UNITED STATES PATENT AND TRADEMARK OFFICE

APPLICATION NO.	FILING DATE	FIRST NAMED INVENTOR	ATTORNEY DOCKET NO.	CONFIRMATION NO.
10/658,681	09/09/2003	Travis Hess	2949.2.137	2262

Office Action Summary	Application No. 10/658,681	Applicant(s) HESS ET AL	
	Examiner Joseph D. Pape	Art Unit 3612

DETAILED ACTION

FIG. 2

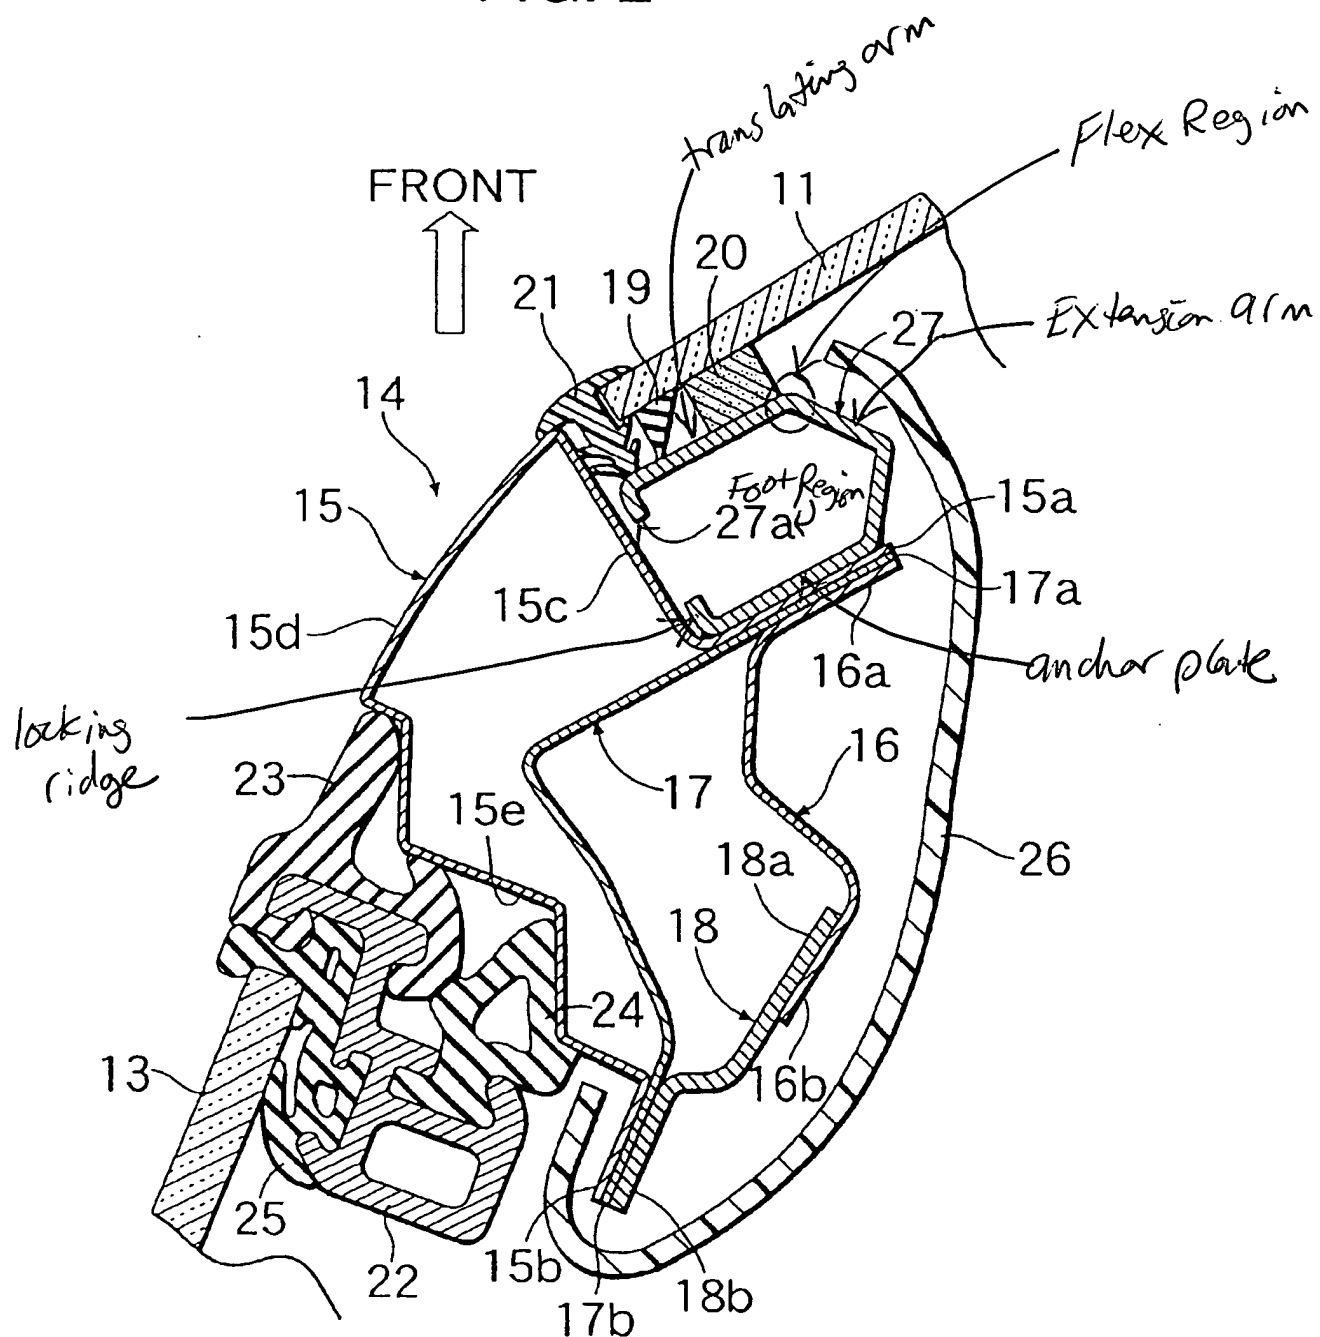
7. Claims 1-5, 12, and 18-20, as understood, are rejected under 35 U.S.C. 102(b) as being anticipated by Enomoto et al.

See the attached marked up copy of Figure 2 of Enomoto et al. showing how the claimed features relate to the reference.

Enomoto et al. is considered to be capable of functioning to deform to absorb energy for the support foot to contact the anchor plate provided a great enough force is applied.

FIG-6

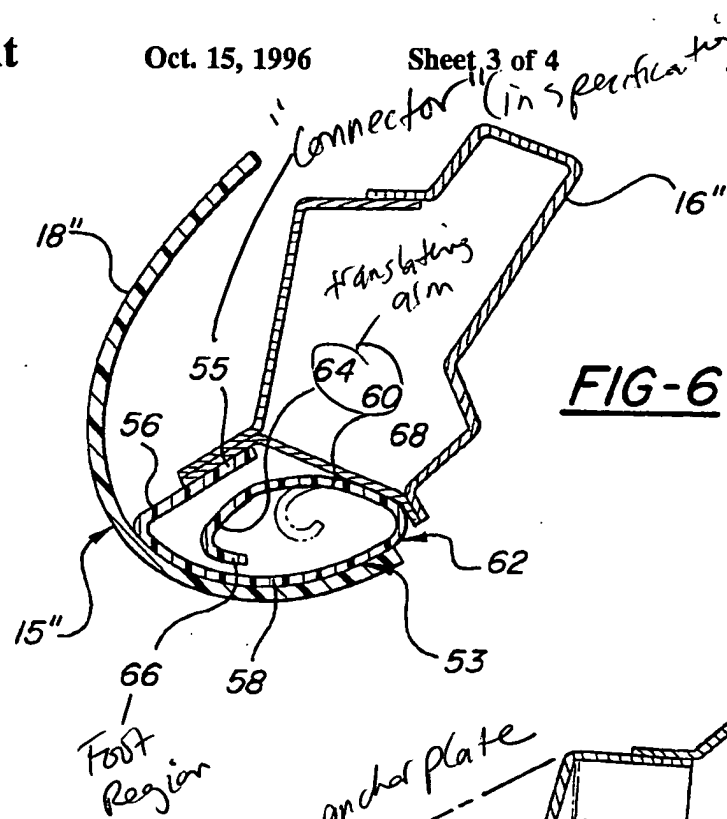
8. Claims 1, 15, 18, and 33, as understood, are rejected under 35 U.S.C. 102(b) as being anticipated by Frost.

See the attached marked up copy of Figures 6 and 7 of Frost showing how the claimed features relate to the reference.

Frost is considered to be capable of functioning to deform to absorb energy for the support foot to contact the anchor plate provided a great enough force is applied.

Support foot
is 60, 64 + 66
